DEPARTMENT OF THE AIR FORCE
HEADQUARTERS SACRAMENTO AIR LOGISTICS CENTER (AFMC)
McCLELLAN AIR FORCE BASE, CALIFORNIA

8 July 1997

Per your 7 May 97 letter, Subject: Request for Additional Information (TAC NO. M96343), we have provided the additional information you requested.

Questions/Responses

Figure 11.1 Reactor Bulk Shield Direct Dose Rate - 1 MW Operation

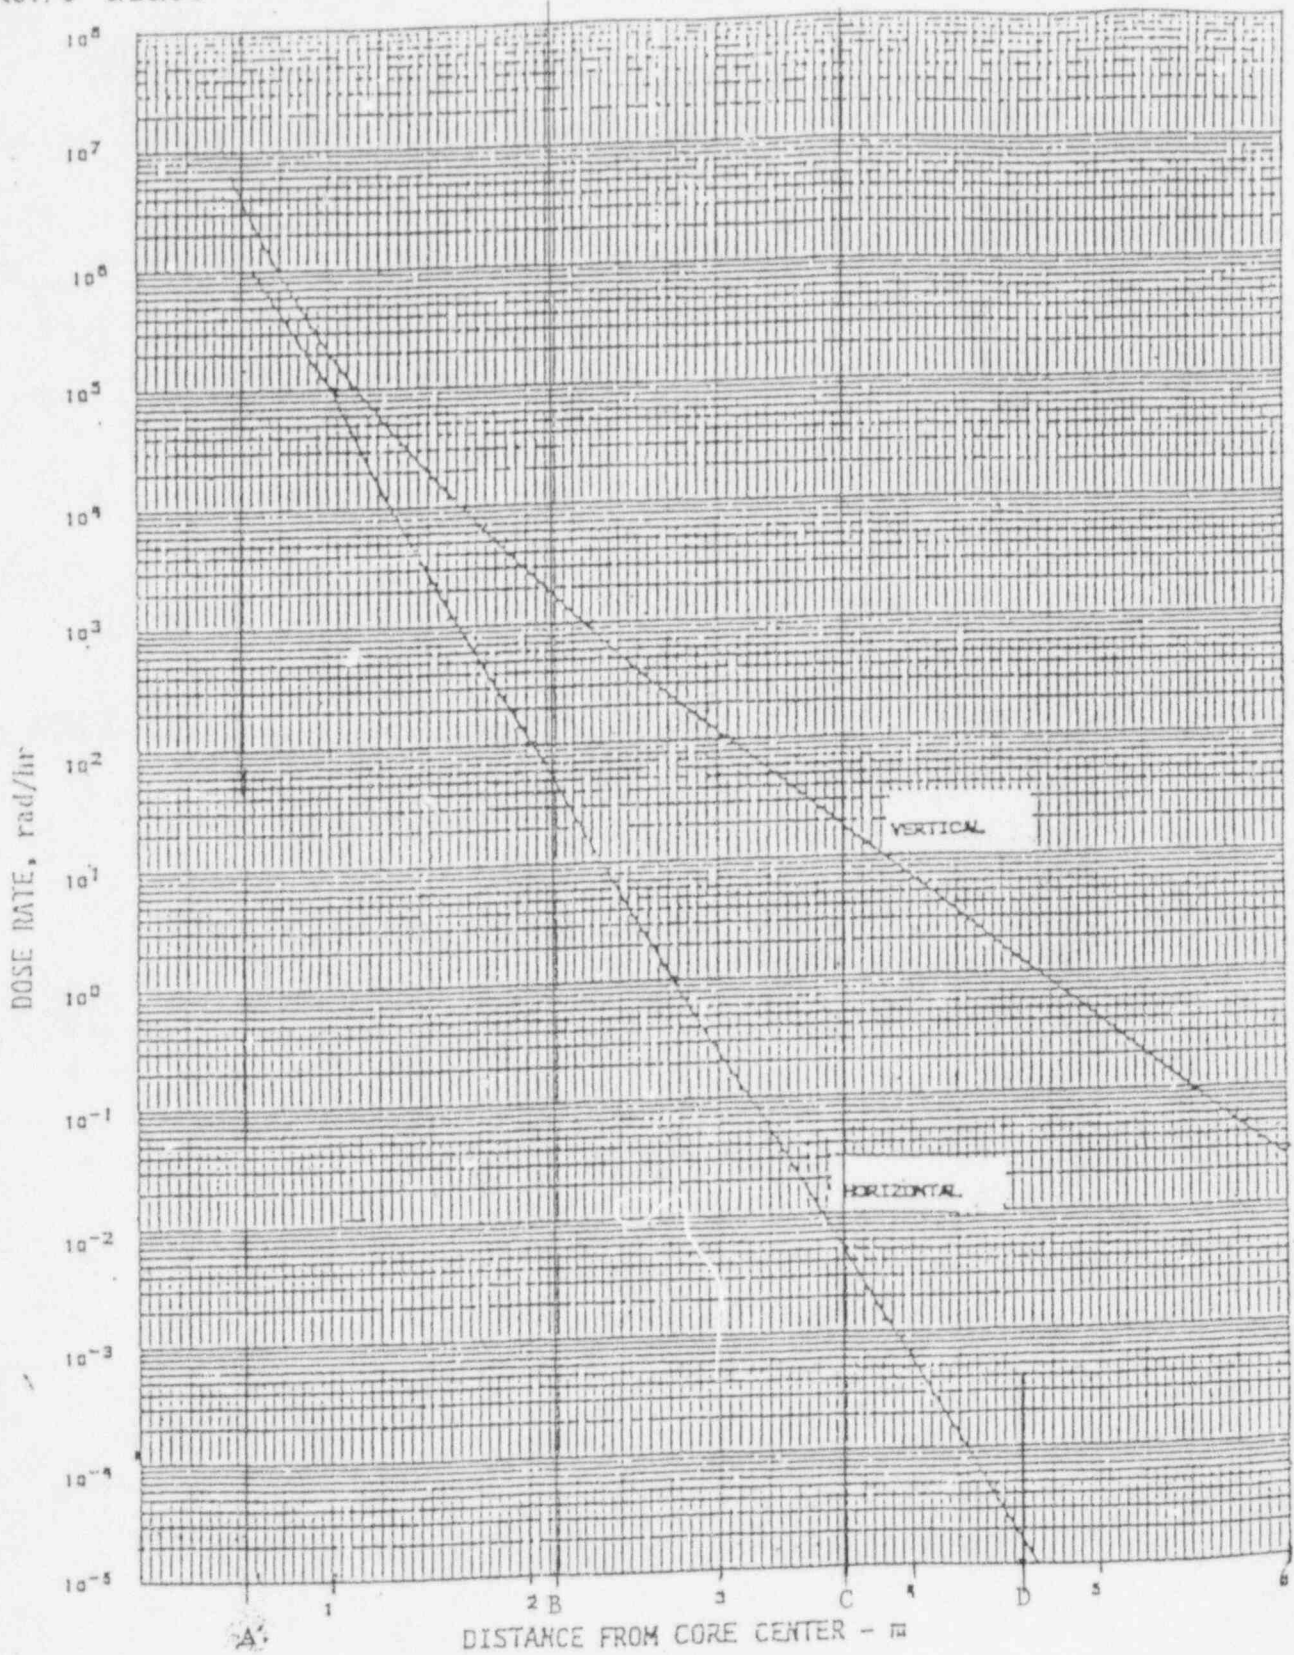
SAR, page 11-14: Please provide a new Figure 11.1 that also defines the boundaries for the core, tank wall, and outer surface of the biological shield.

Drawing was revised as requested.

A: Core Boundary
C&D: Biological Shield

B: Tank Boundary

Control Rod Worth Curve

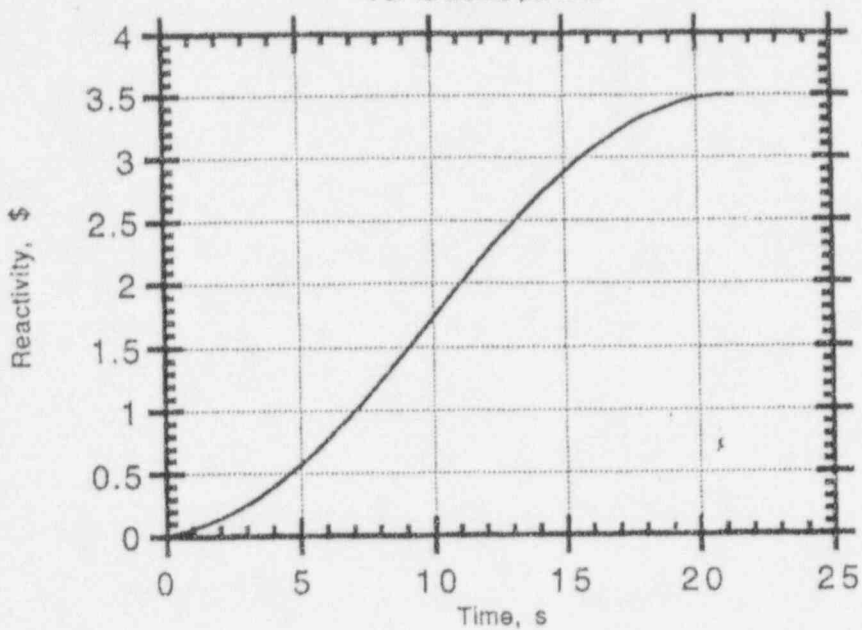
SAR, pages 13-8 and 13-9: Please provide your calculation of the "Uncontrolled Withdrawal of a Control Rod" using the proposed Technical Specifications limits for:

Of particular interest will be the value of the "maximum positive reactivity insertion" (is this at any time greater than \$2.12?)

Changing the SAR control rod drive (Rack & Pinion Drive) maximum speed from 7.5 inches/s to 42 inches/min results in slower transients and yields more flexibility in setting technical specifications limits for control rod worth.

The conservative value for power_level channel delay time (0.5 s) used in the SAR dose not impact the outcome of the transient as it did with the faster insertion rate (7.5 inches/s) assumed in the SAR.

The maximum positive reactivity insertion for all the cases listed above are much less than the \$2.12 maximum reactivity insertion that can be allowed under worst case conditions, SAR (Section 13.2.2.2.1).
